WARRANTY BULLETIN QUALITY

Campaign no.: 2020-0006

Subject: **Spyder® RT - Abnormal Gaps Around the Rear Cargo Module Access Covers**

No. **2020-4**

rbg2020-002-010

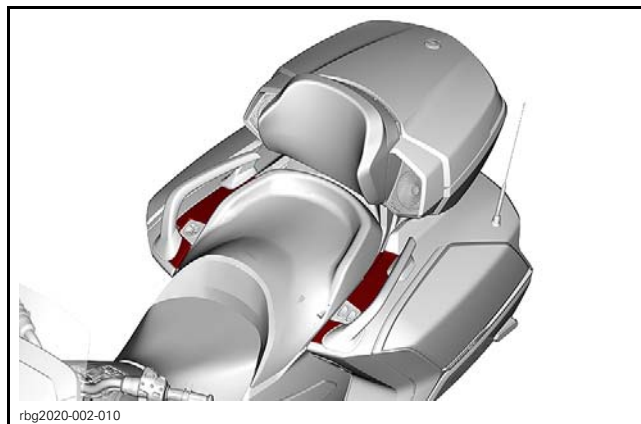
On some Spyder RT manufactured since February 6th, abnormal gaps may be present between both rear cargo module access covers and adjacent body parts.

Replace both access covers.

1. Remove the passenger seat.
2. Remove and keep both screws securing the access cover.
3. Remove and discard the access cover.
4. Position the access cover and loosely install the previously removed screws.
5. Move the access cover to have an equal gap in back and in front.
6. Hold the access cover in this position and tighten screws.
